| RE: Service Campaign 2013040003- Model 212 (E-Class), 218 (CLS), Model Year 2013. Re-torque Horn Bracket Bolt | DATE: May 3, 2013 |

Service Campaign Bulletin

Campaign No. 2013040003, May 2013

SUBJECT: **Models 212, 218, Model Year 2013**
Re-torque Horn Bracket Nut

Procedure**Figure 1**

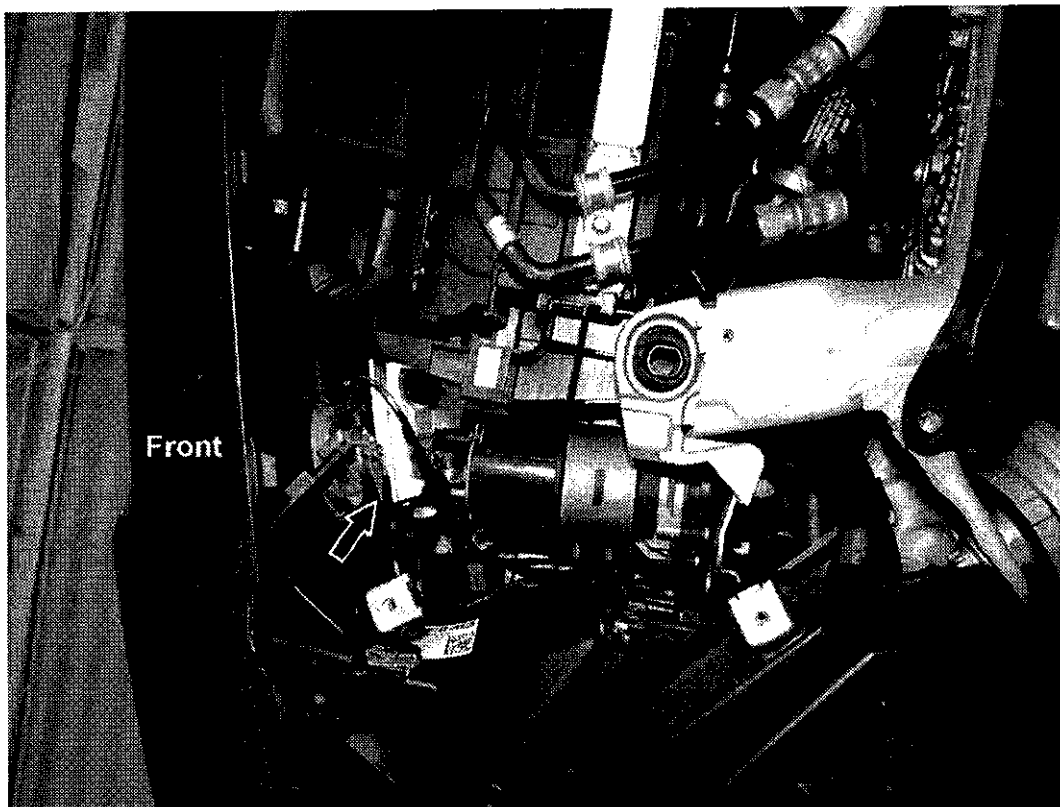
1. Remove front lower engine compartment paneling; refer to WIS: AR61.20-P-1105EW.
2. Re-torque right horn mounting nut (arrow, Figure 1):

- Loosen horn mounting nut (arrow) using a wrench or ratcheting box wrench (locally procured).
- Re-torque nut (arrow) to 9 Nm using a 10 mm crow-foot wrench attached to a torque wrench. Repeat this process a **total** of 3 times.
- Remove nut (arrow) and apply thread-locking compound (shop supply) to threads then re-torque a fourth time to 9 Nm.

Be sure to position right horn back to installed position on bracket before re-torquing nut (arrow) for final time.

Figure 2 (Arrow points to horn mounting nut)

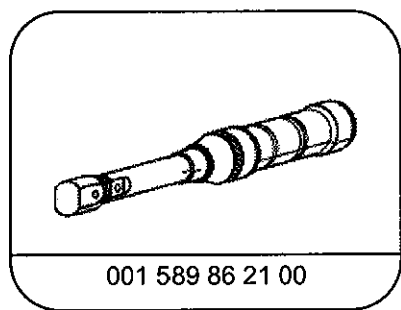
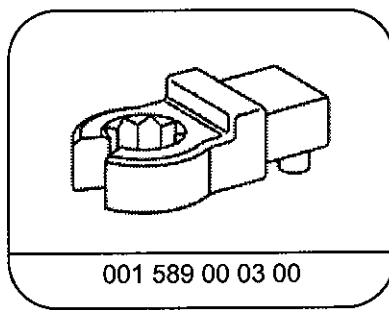
Note: Refer also to Figure 2.
